From: Natalie Biddulph <Natalie.Biddulph@westsussex.gov.uk> on behalf of OW Consent <OWC@westsussex.gov.uk>
Sent: 16 June 2026 12:43
To: Emma Luckman; Duncan Keir
Cc: OW Consent; sarahjplatt@gmail.com; Mark Pettitt
Subject: RE: Ordinary Watercourse Consent Application WSCC-830865954 (The Foal Barn, Wyndham Farm BN5 9AN)
Attachments: Wyndham Farm FRADS_P05.pdf

Ordinary Watercourse Consent Application WSCC-830865954 (The Foal Barn, Wyndham Farm BN5 9AN)

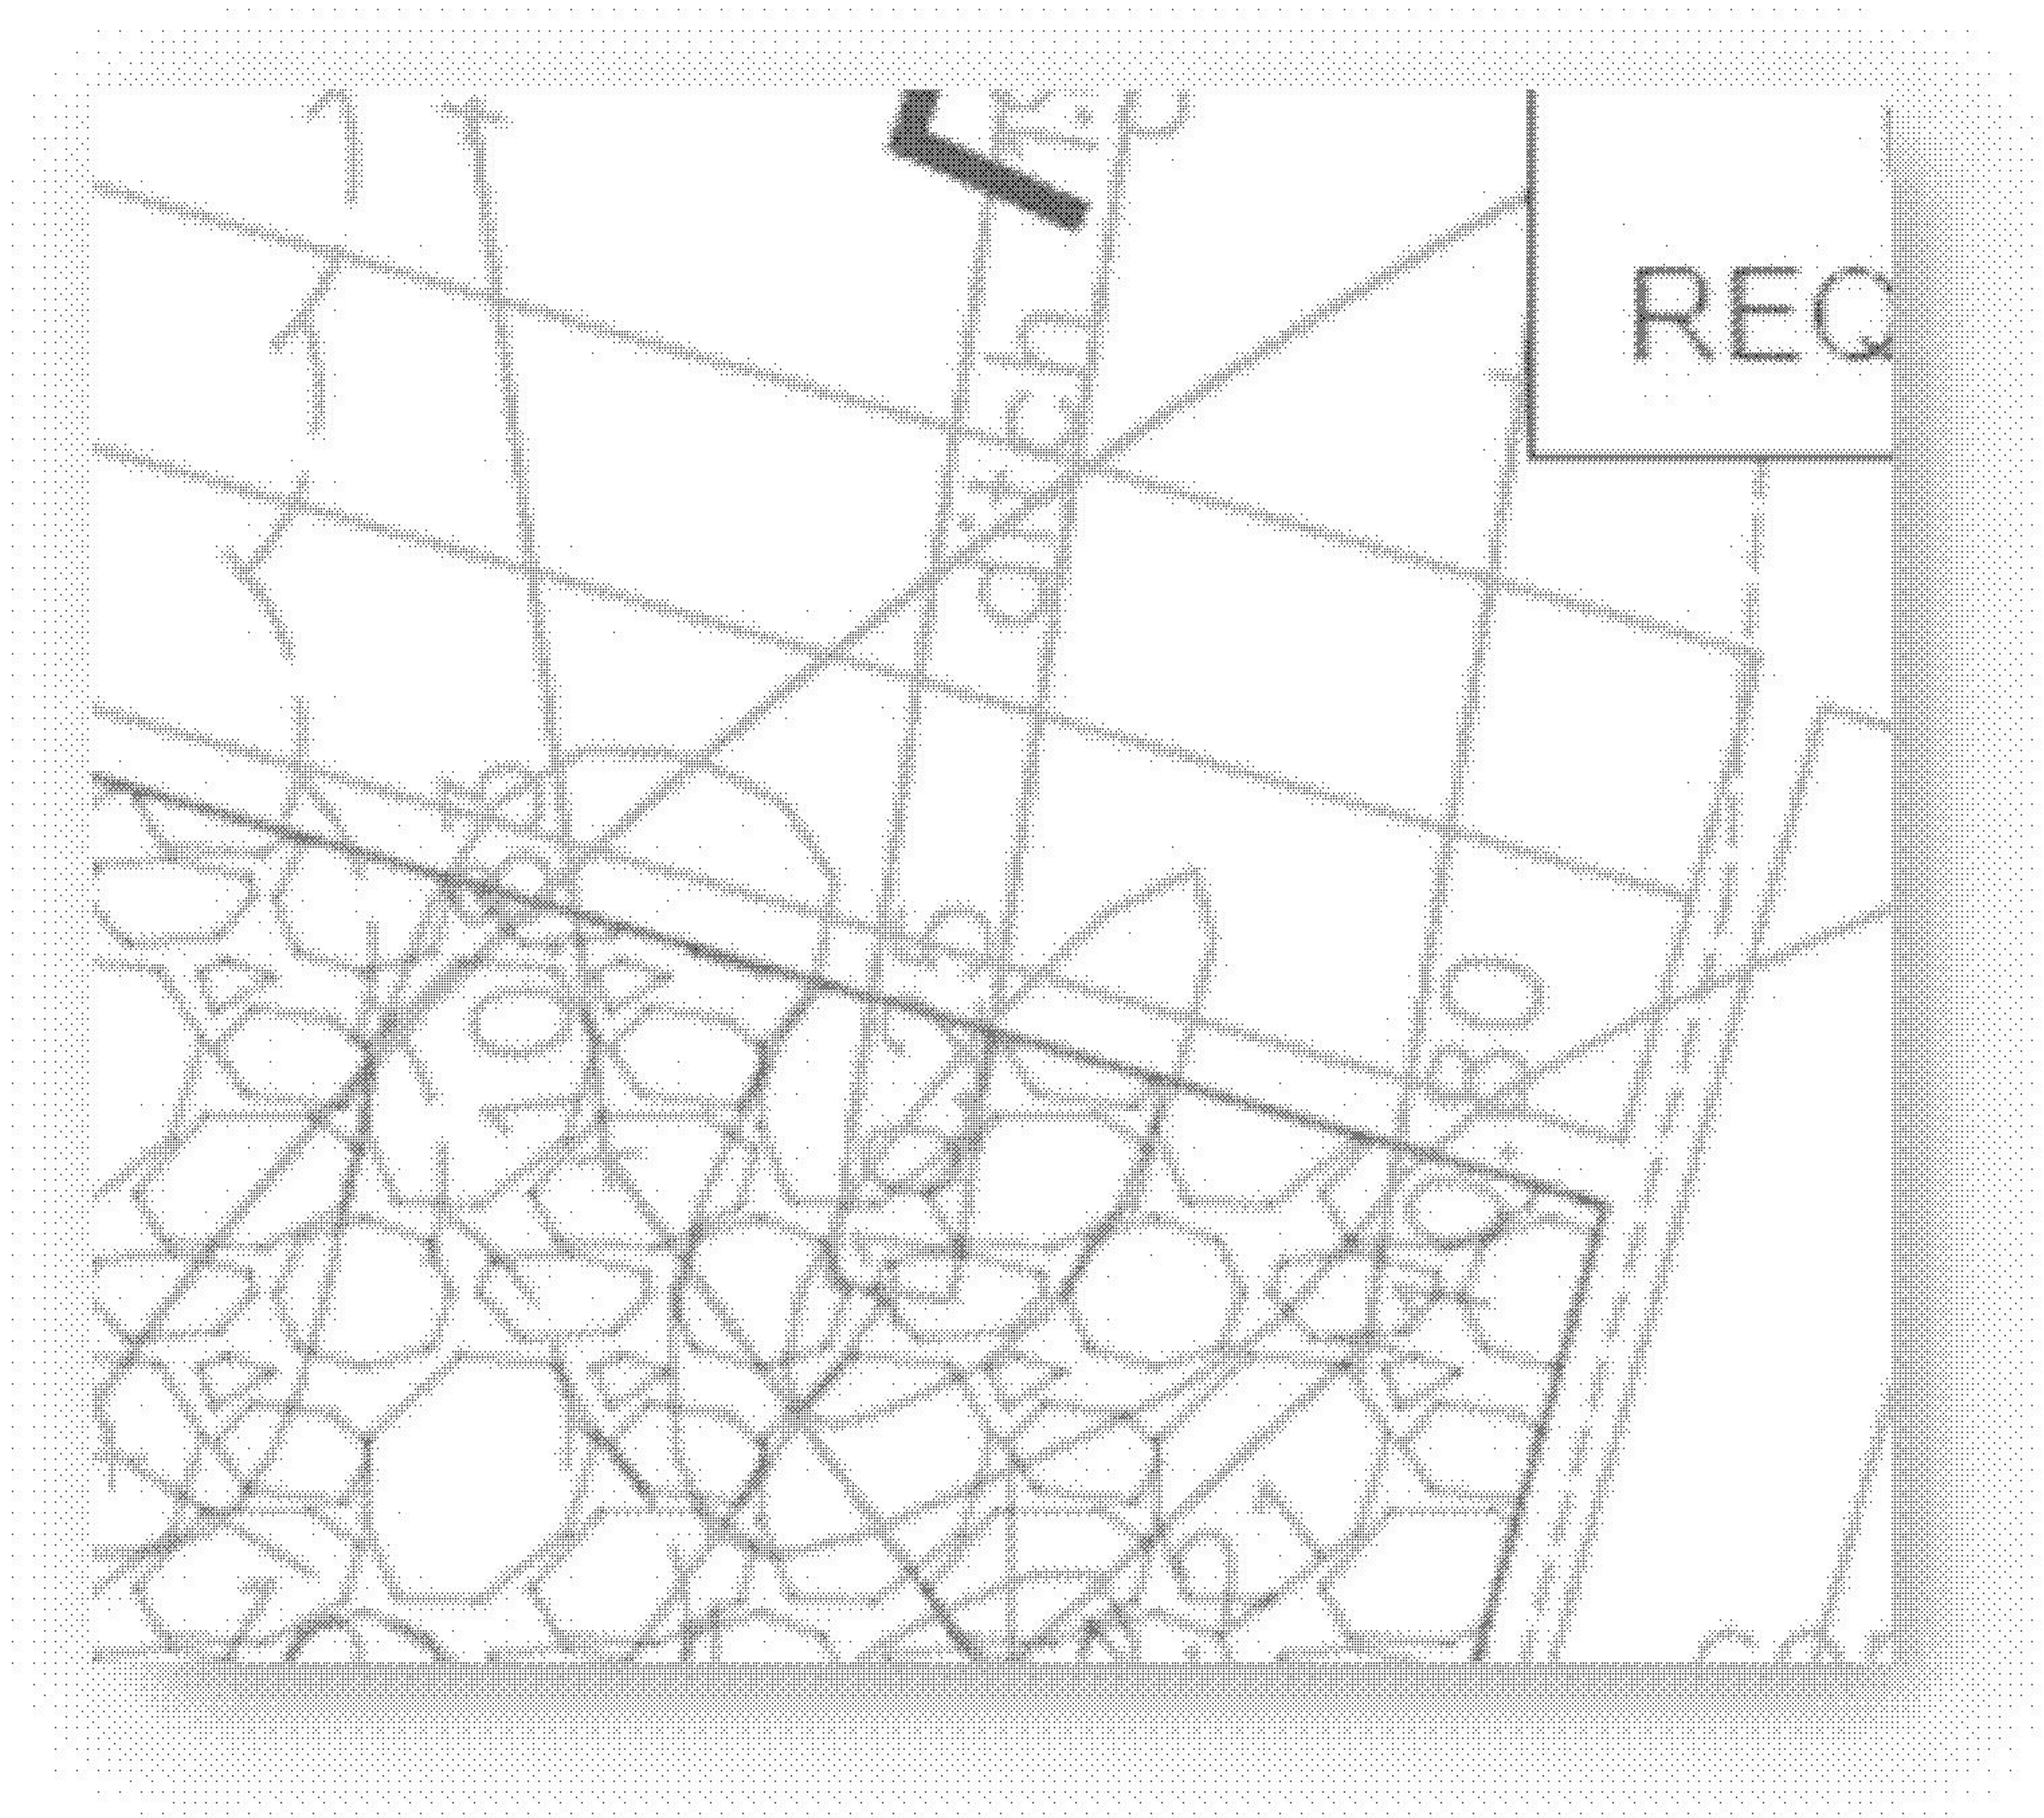
2. When appraising the documentation submitted in support of your consent application, I noted that the “proposed drainage layout” (drawing: P00016-AAH-C-DRW-3001 P04) shows that some of the proposed development is located directly over a section of the existing open watercourse. (See excerpt below). This conflict will obviously need to be resolved, and the resolution will require “works” to be undertaken to the existing watercourse (such as a new section of culvert and associated headwall, to extend the existing culvert). Unlike the proposed new surface water discharge headwall, any online work to an existing ordinary watercourse **will** fall within the scope of the consent process. Therefore, I will need you to provide details of the works that you propose at this location. (I suspect that the required works will attract more than the single £50 fee that you have paid for the current application, please refer to our consent fee schedule document:

We have now received a revised site layout, evidencing development is now to be situated away from the ditch illustrated in point 2 below. Please see attached revised FRA showing this.
